SIB 18 02 25

RATTLING NOISE FROM REAR MUFFLER (G45 – B48P ENGINE)

G45	X3 Sport Activity Vehicle with the B48P 4-cylinder engine
-----	---

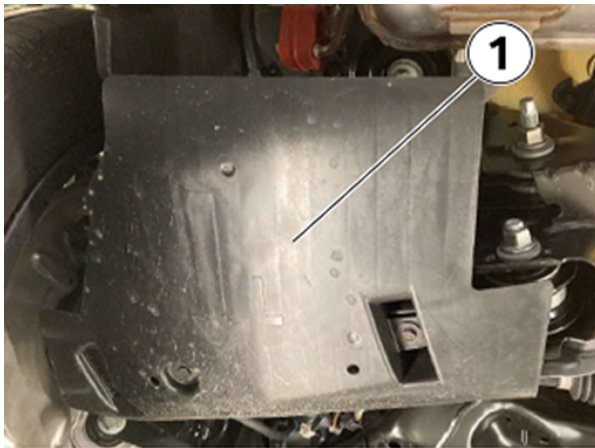
Clearance between the heat shield and rear muffler may be out of tolerance (too close).

Install two (2) 3 mm washers between the body and rear exhaust hangers.

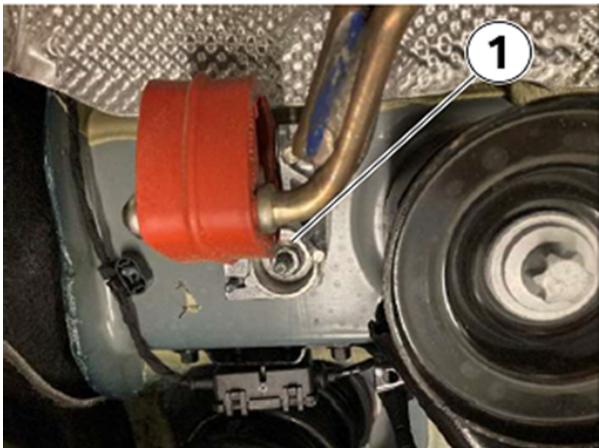
Remove the protective cover (1). NOTE: Tightening torque for screw is 3 Nm.

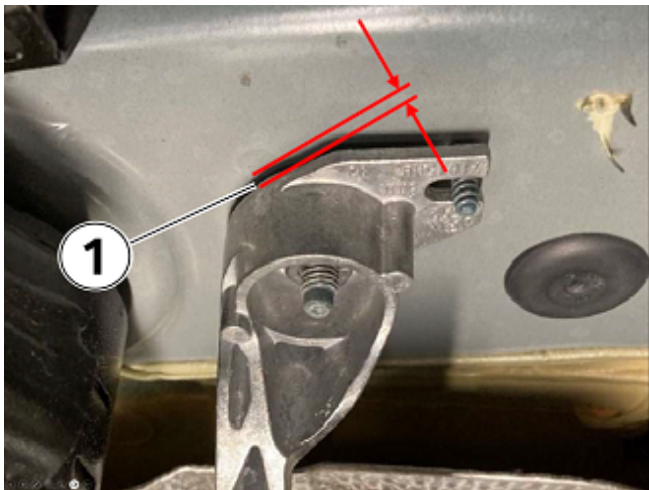
Remove the nut holding the rear exhaust hanger (1).

Install the 3 mm washer onto the hanger (1) (use a small amount of sealant to hold the washer to the hanger).

Reinstall the hanger and replace the nut. Tightening torque 19 Nm. There will be a gap between the body and the hanger (1).
